VEHICLE SAFETY DEFECT  
INITIAL INFORMATION REPORT  
WATER HOSE CLAMP  
RECALL No. 159

**RECALL CAMPAIGN NO. 159**

**SUBJECT :** Recall Campaign No. 159  
Ferrari F355 Water Hose Clamp

REF. NO. 159  
WATER HOSE CLAMP  
F 355

INSTRUCTIONS FOR WATER HOSE CLAMP ADJUSTMENTA: Procedure for Adjustment

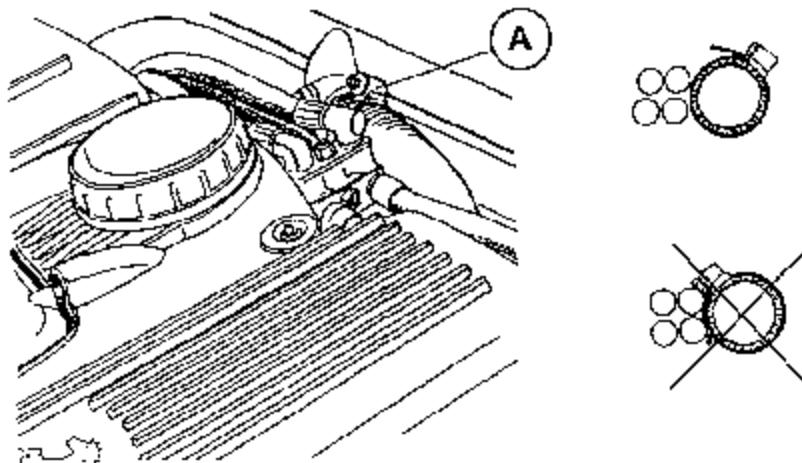
**CONDITION :** The potential for the fuel injection line to wear due to interference with the water hose clamp on the coolant pipe exists.

**REMEDY :** Checking and reattaching the incorrectly fitted water hose clamps, as per the diagram.

1. Rotate the clamp (p.n. 12177090) which connects the water hose to the coolant pipe as per the above diagram. Turn and tighten the clamp so there is enough clearance as to not interfere and damage the fuel line 171344 (old p.n. 165533).

**NOTE: FOR IDENTIFICATION PURPOSES, PLEASE PAINT A YELLOW SPOT  
ON THE WATER HOSE**

## INSTRUCTIONS FOR WATER HOSE CLAMP ADJUSTMENT

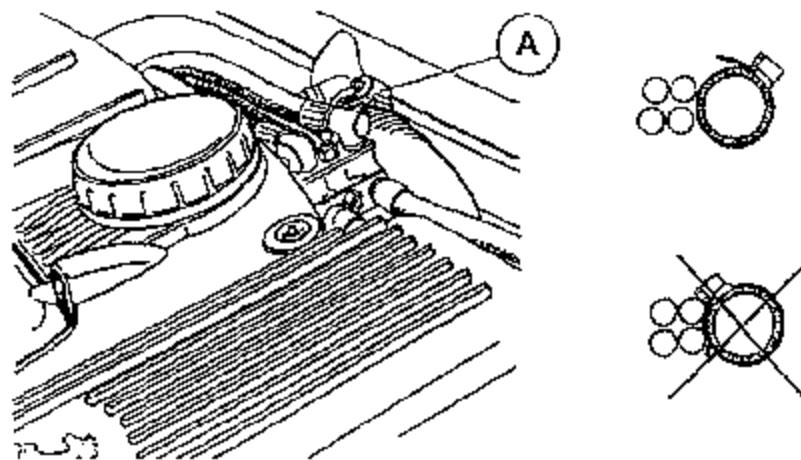
**CONDITION :** The potential for the fuel injection line to wear due to interference with the water hose clamp on the coolant pipe exists.

**REMEDY :** Checking and rotating the incorrectly fitted water hose clamps, as per the diagram.

1. Rotate the clamp (p.n. 12177090) which connects the water hose to the coolant pipe as per the above diagram. Turn and tighten the clamp so there is enough clearance as to not interfere and damage the fuel line 171344 (old p.n. 165533).

**NOTE: FOR IDENTIFICATION PURPOSES, PLEASE PAINT A YELLOW SPOT  
ON THE WATER HOSE**
